1984 - 1985 Corvette: Service Bulletin: Door Ajar Switch Corrosion

Subject: Door Ajar Switch Corrosion

Bulletin Number: 85-43, Number 8B (XII) & 10(I)

- REPLACEMENT 14087681 DOOR AJAR SWITCH
(WITH SLEEVE)

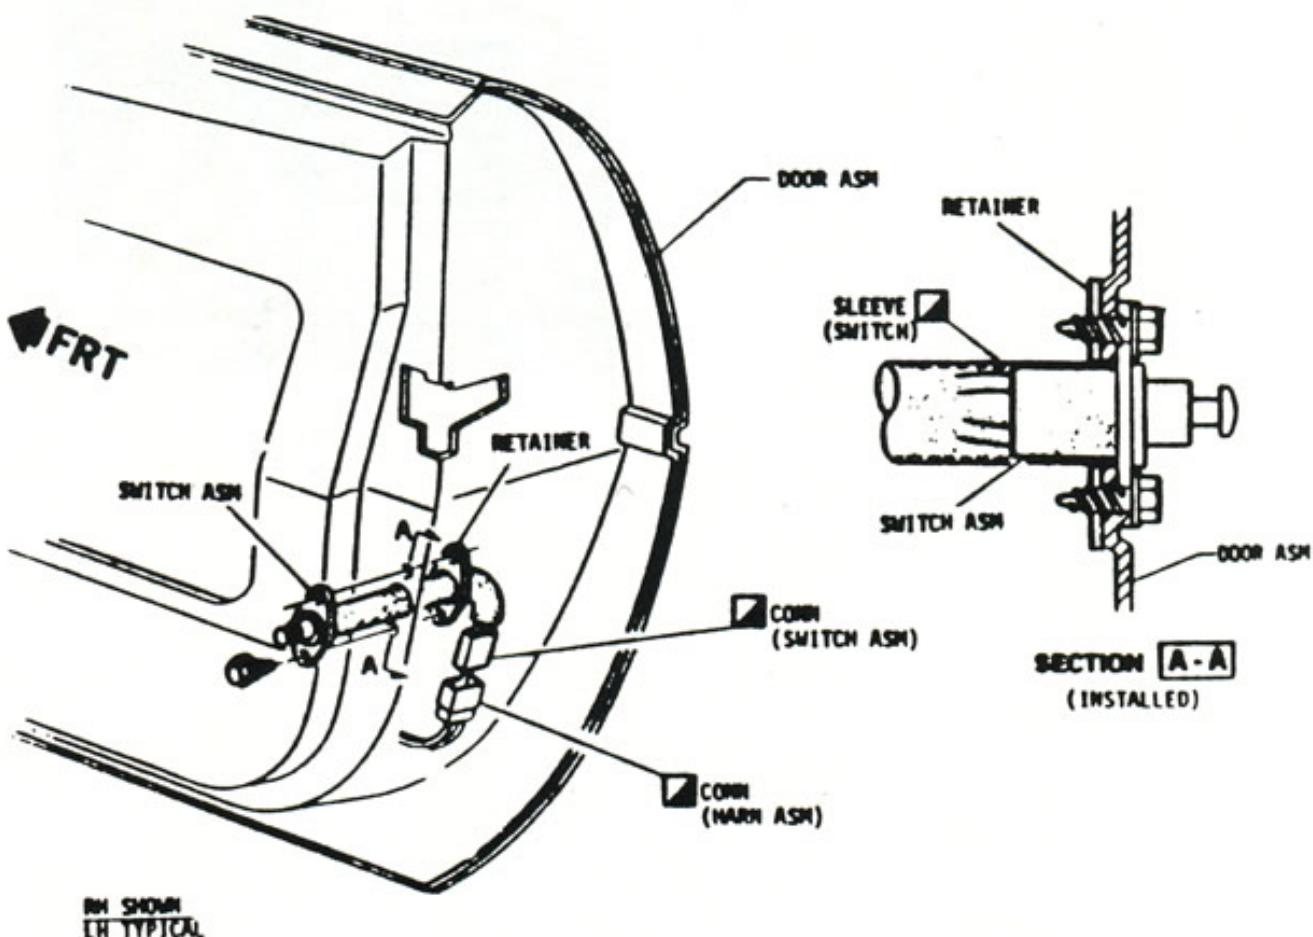
SOME 1984 AND EARLY PRODUCTION 1985 CORVETTE DOOR AJAR SWITCHES (P/N 14062556) MAY BECOME INOPERATIVE DUE TO INTERNAL CORROSION. THIS CAUSES THE DOOR AJAR LIGHT TO EITHER BECOME INOPERATIVE, FLICKER, OR STAY ON.

A NEW CORROSION RESISTANT SWITCH (P/N 14087681) AND AN ASSOCIATED RETAINER (P/N 14087682) ARE TO BE USED AS SERVICE REPLACEMENTS. THE NEW SWITCH INCLUDES A SLEEVE (SEE ILLUSTRATION) THAT FITS TIGHTLY AROUND THE SWITCH'S HOUSING AND HAS SUFFICIENT LENGTH TO COVER THE WIRE CONNECTOR ONCE CONNECTION TO THE DOOR HARNESS IS MADE.

WHEN REPLACING THE EXISTING SWITCH WITH A NEW 14087681 SWITCH, THE DOOR INSERT HOLE WILL NEED TO BE ENLARGED FROM 16MM TO 18MM TO ACCOMMODATE THE SLEEVE PROVISION. CARE MUST BE EXERCISED WHEN ENLARGING THE INSERT HOLE SO THAT ADJOINING MOUNTING HOLES ARE NOT ALTERED. SCRATCHES, CHIPS, ETC., TO DOOR PANEL SURFACE RESULTING FROM THE HOLE ENLARGING PROCESS ARE TO BE COSMETICALLY REPAIRED AS OUTLINED IN SECTION 10 (BODY) OF THE CORVETTE SHOP MANUAL.
